Bid Bulletin #03

PROJECT: Weeping Water Public Schools
Additions & Renovations
Weeping Water, NE

RE: Addendum No. 2 to the Bidding Documents for:
Weeping Water Public Schools
Additions & Renovation
204 West O Street
Weeping Water, Nebraska 68463
Schemmer Project No. 06368.001

This addendum consists of nine 9 pages of written addendum items and thirty-three 33 pages of supplemental drawings.

SHEET NO: SDM-6

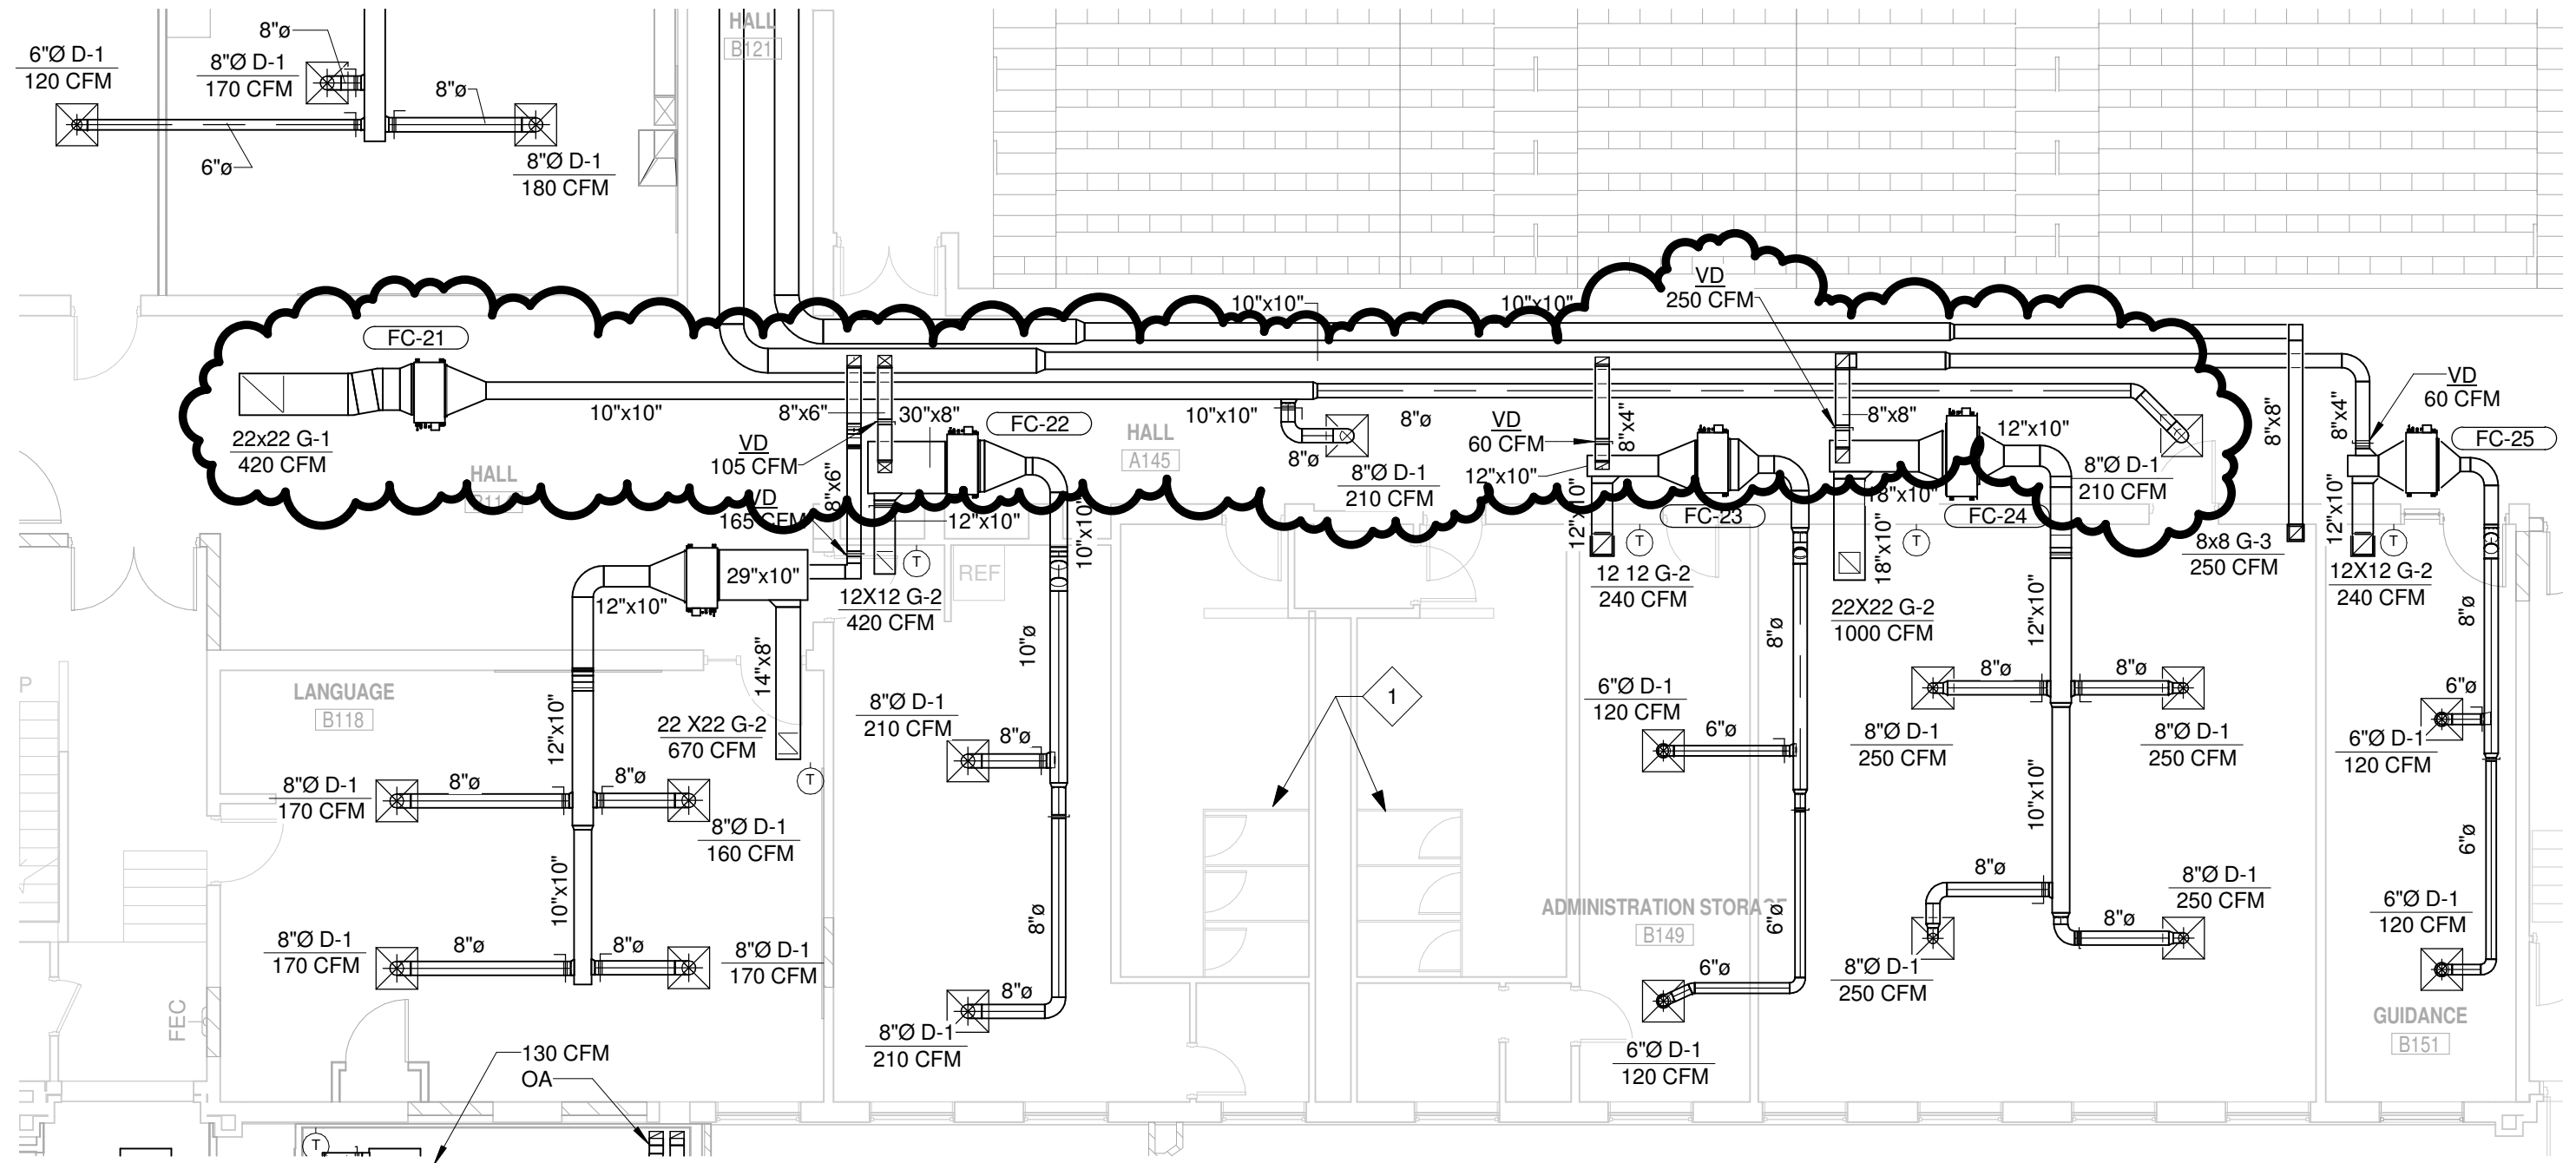
Item No. DM-6, Sheet M1-04

- 1) See supplemental drawings SDM-5 and SDM-6 for added content to this sheet.

SHEET NO: SDM-9

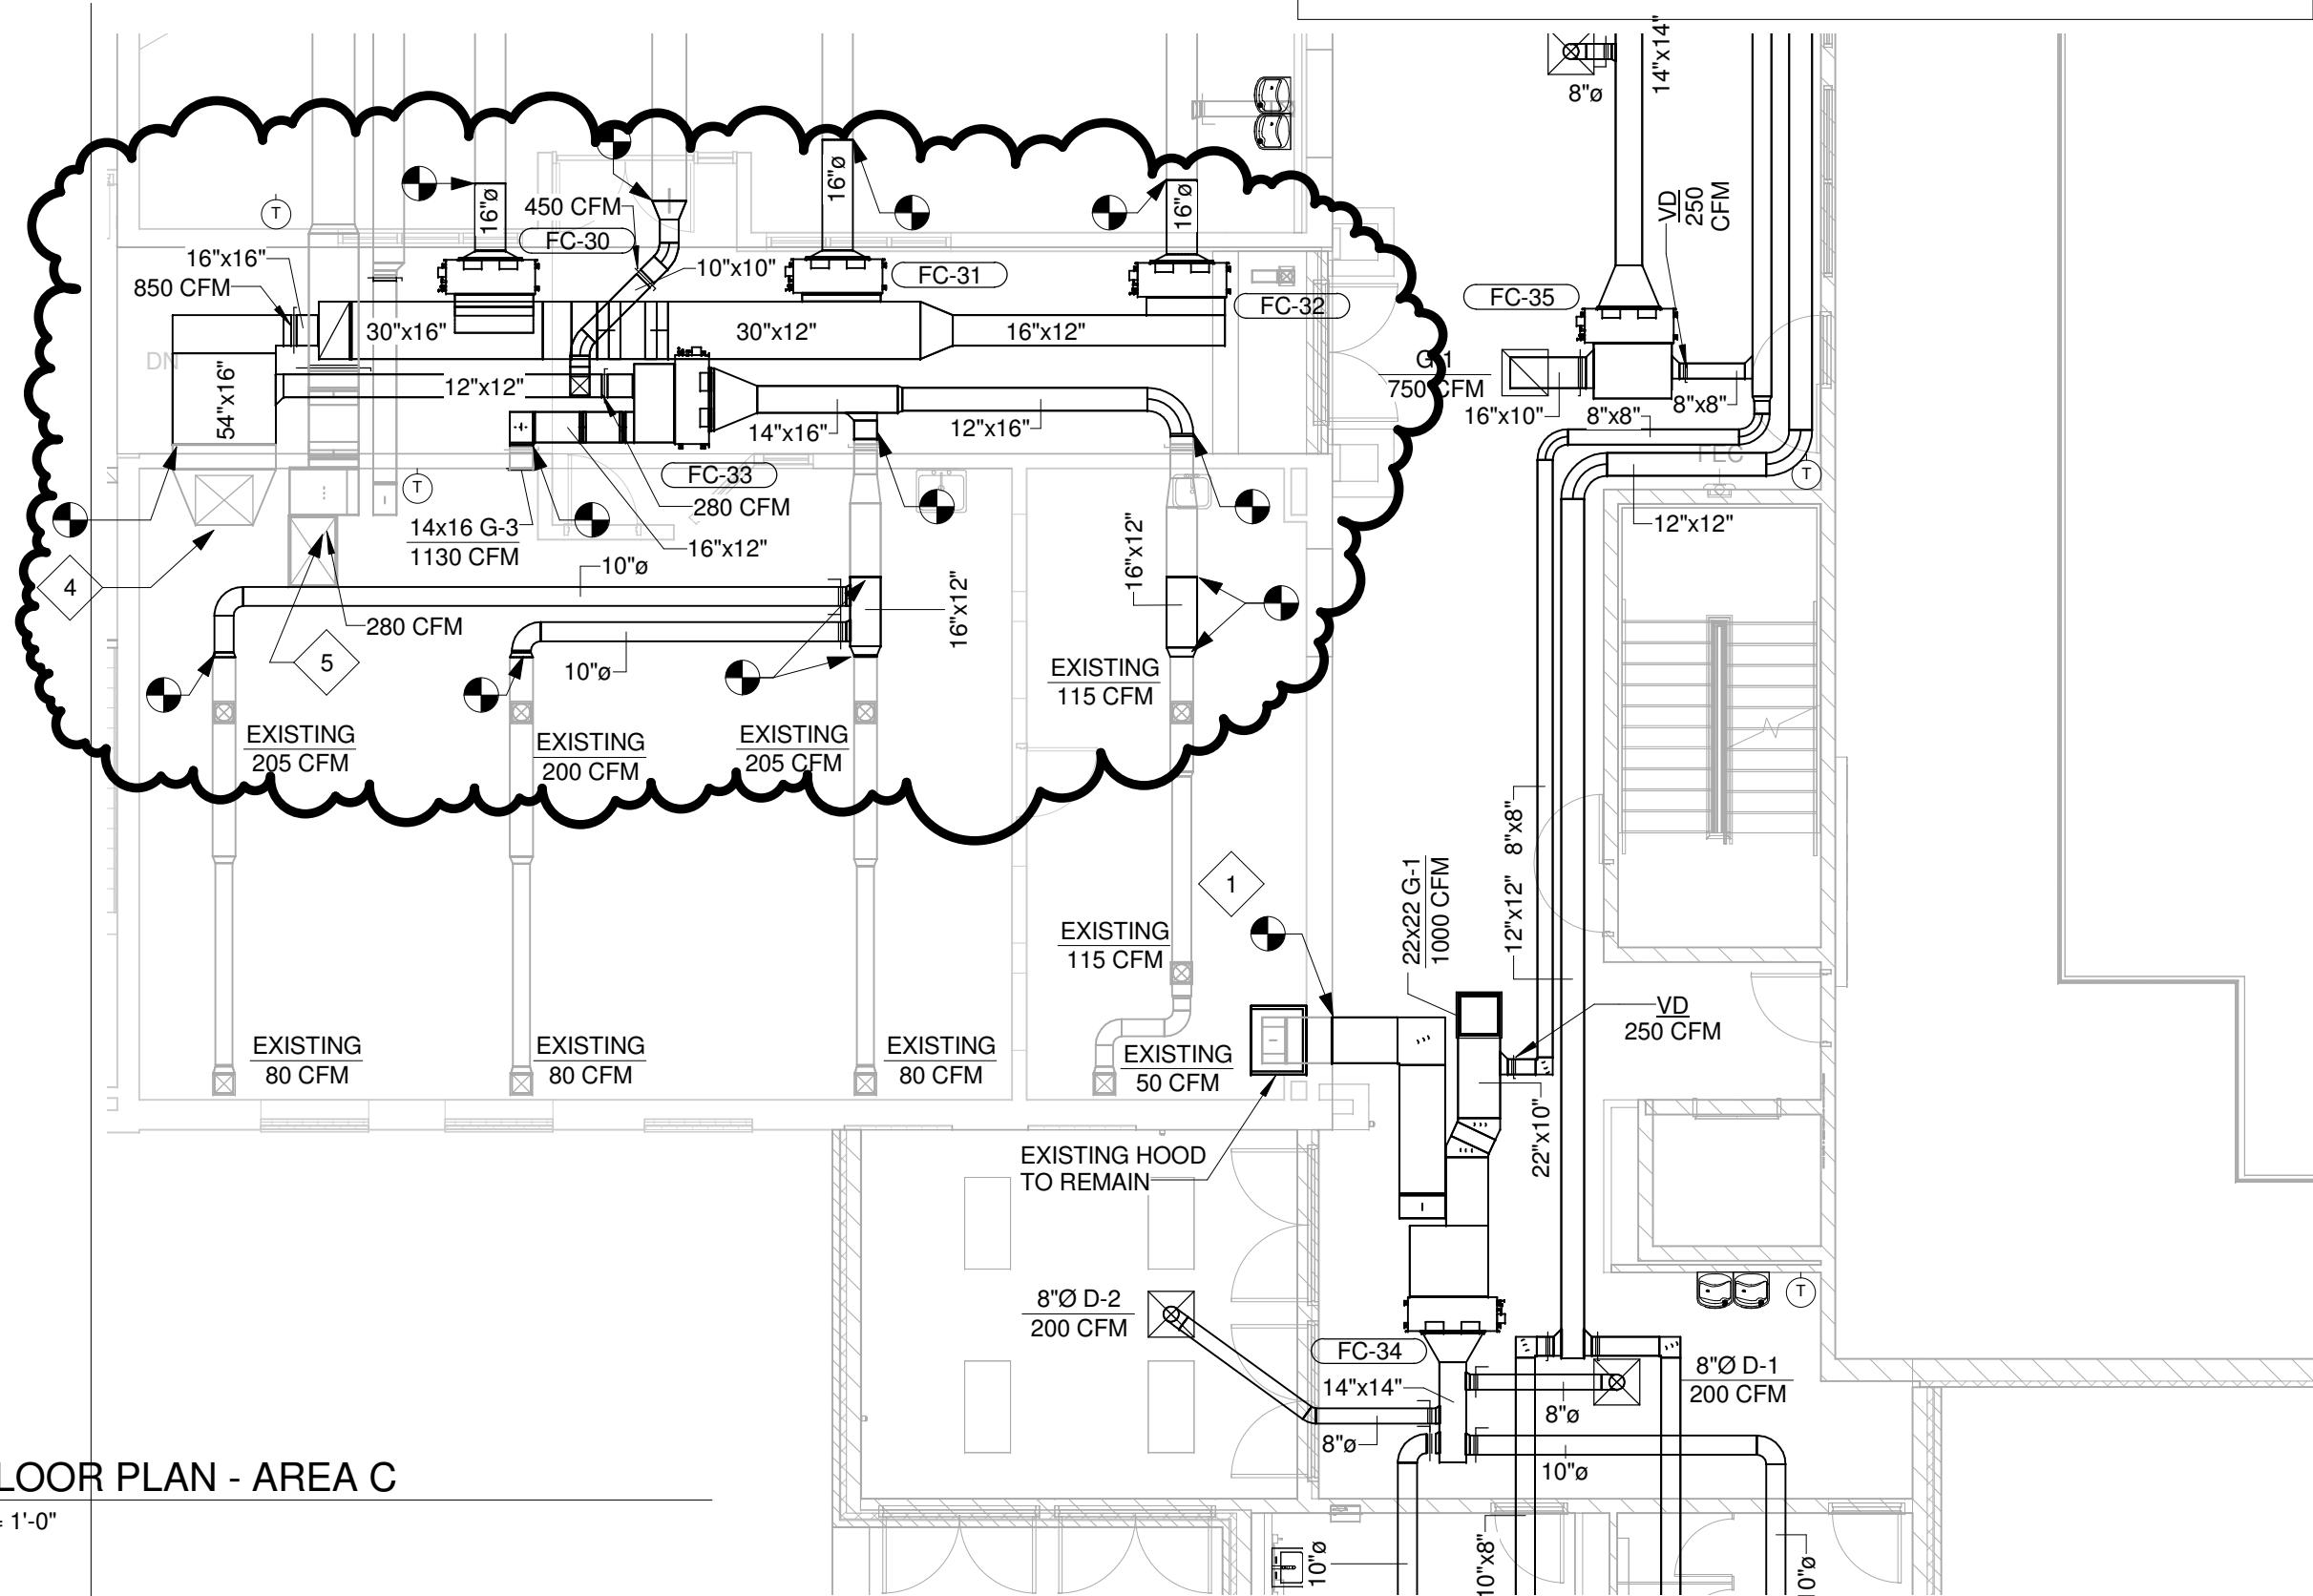
Item No. DM-7, Sheet M1-05

- 1) See supplemental drawings SDM-7, SDM-8 and SDM-9 for added content to this sheet.

SHEET NO: SDM-10

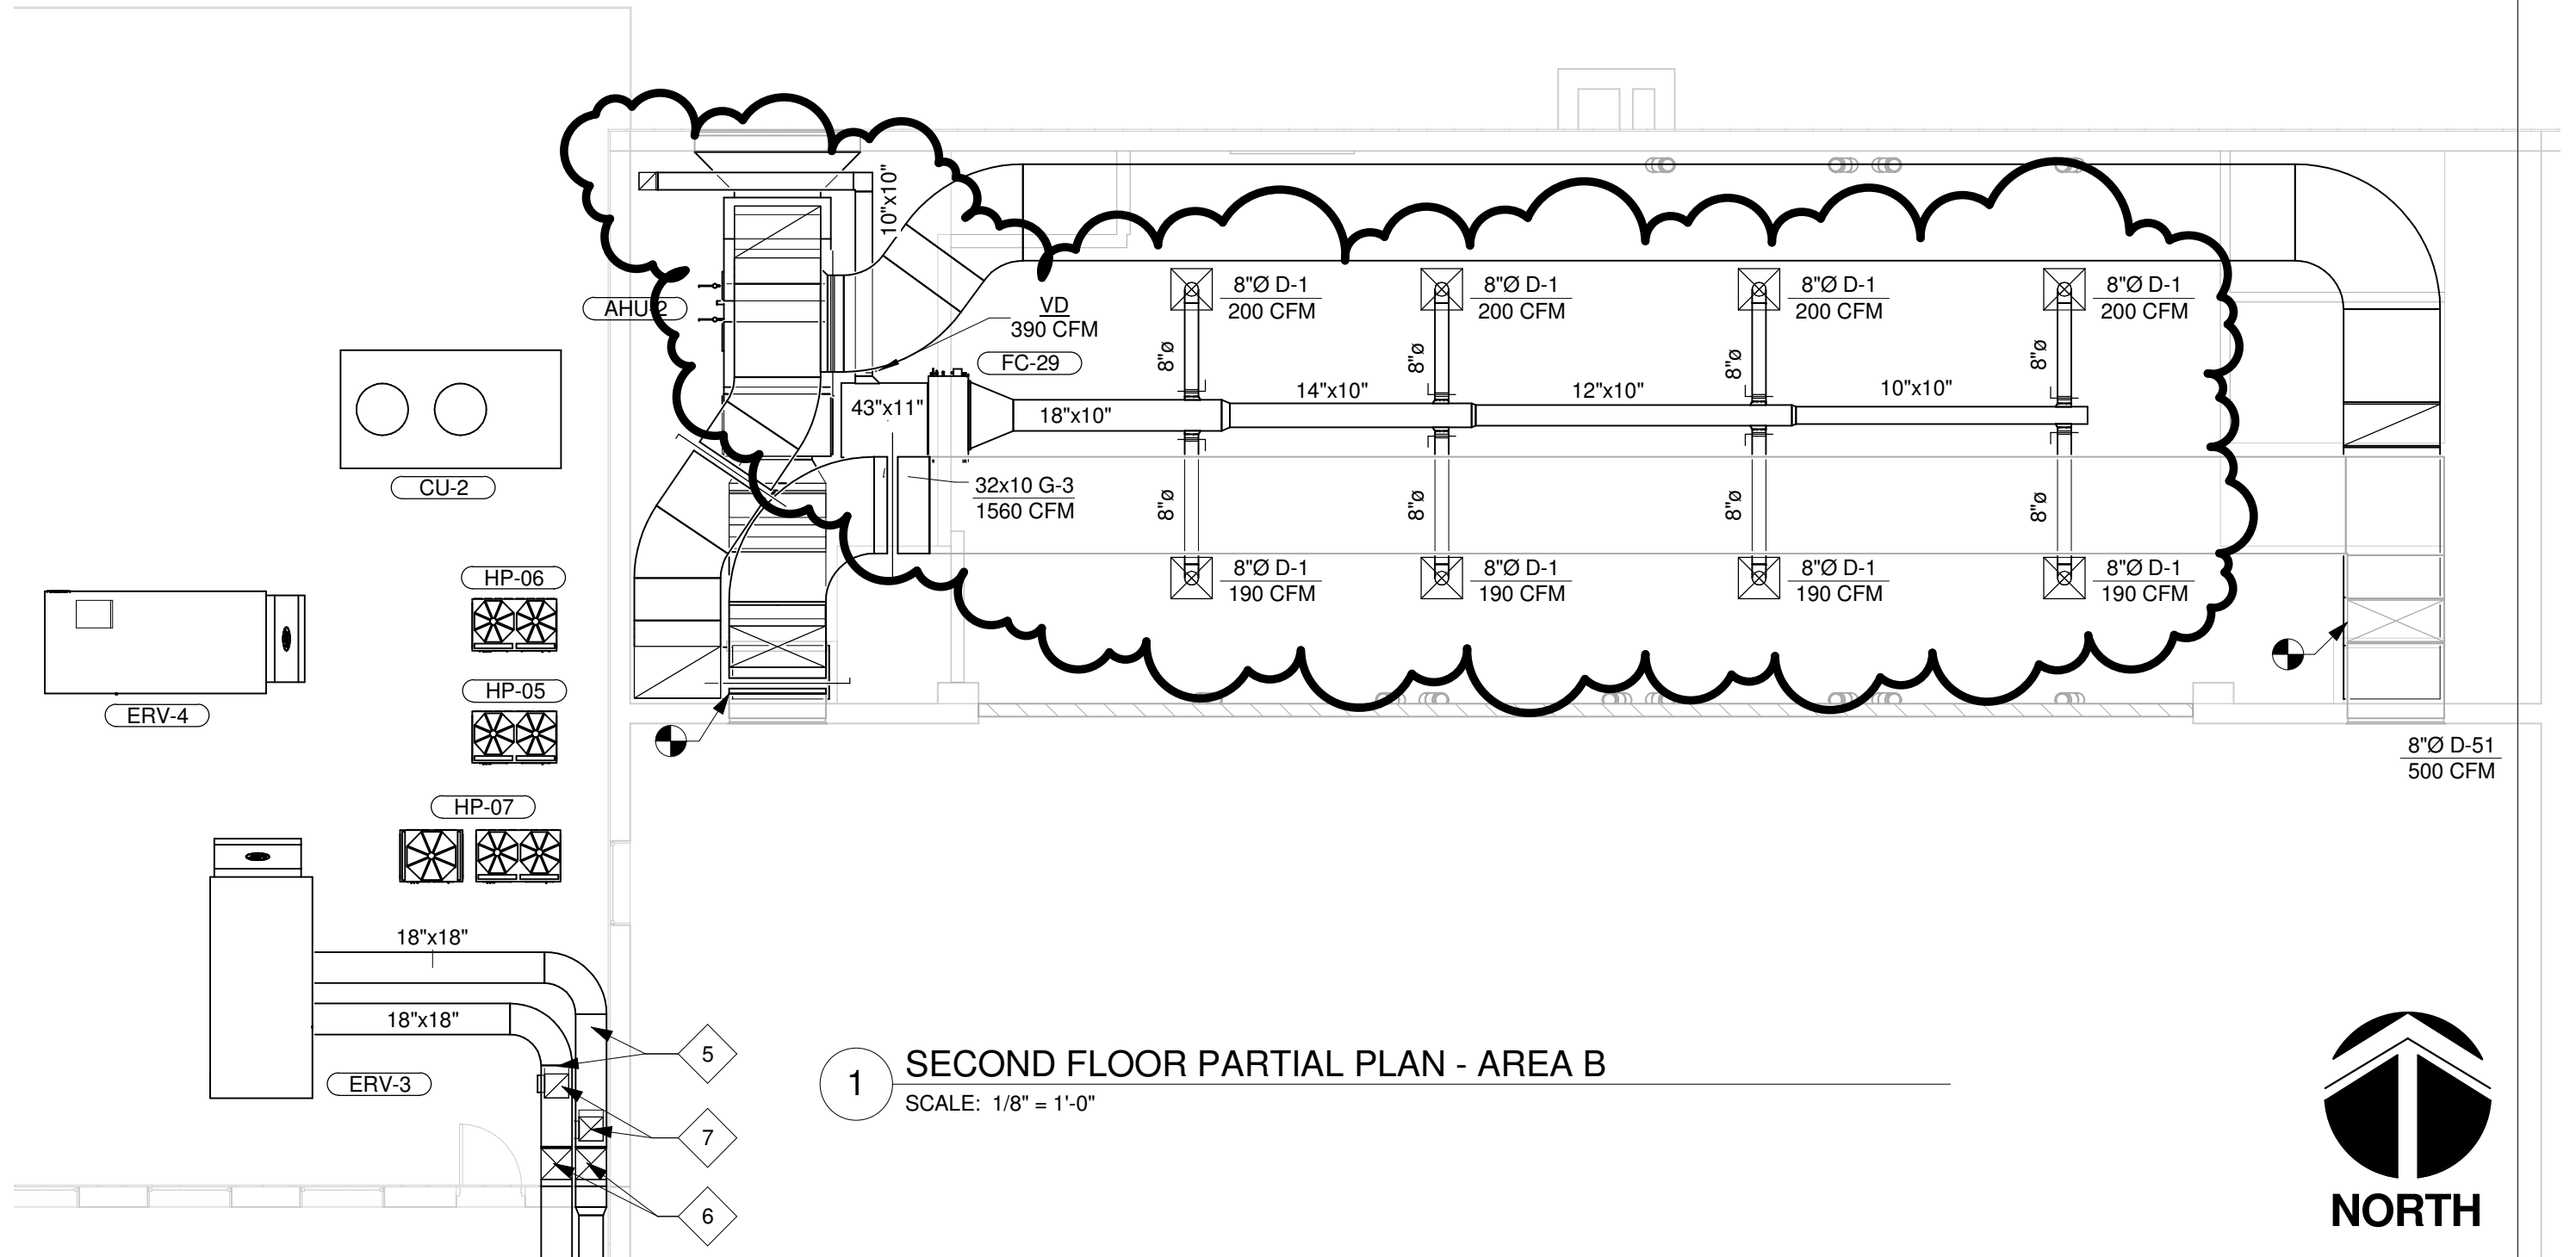
Item No. DM-8, Sheet M1-07

- 1) See supplemental drawing SDM-10 for added content to this sheet.
